# UNITED STATES PATENT AND TRADEMARK OFFICE

APPLICATION NO.	FILING DATE	FIRST NAMED INVENTOR	ATTORNEY DOCKET NO.	CONFIRMATION NO.
10/693,195	10/24/2003	Randall R. Geib	0241-P03282US0	2326
110	7590	03/02/2006	EXAMINER	
DANN, DORFMAN, HERRELL & SKILLMAN 1601 MARKET STREET SUITE 2400 PHILADELPHIA, PA 19103-2307			GARCIA, ERNESTO	
			ART UNIT	PAPER NUMBER
			3679

## Office Action Summary

Applicant's Marked-up Figure 2

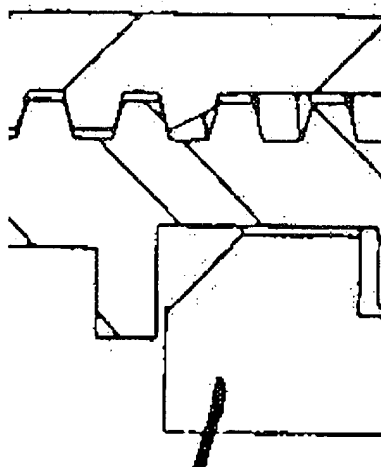
The drawings are objected to because the cross sectional view of the chamfered surface (unreferenced) of the flange 55 is not shown accurately. See attachment of marked-up Figure 2 to find the error in the cross sectional view. Applicant argues that the chamfers are correct; however, the examiner disagrees. Applicant should review the blown-up details in the attachment provided to see the difference between the error and what the drawing must show.

Incorrect

Line must be  
deleted on both  
top and bottom  
chamfers of  
Figure 2

Correct

Notice that the  
proper cross-  
section of the  
chamfer is correct
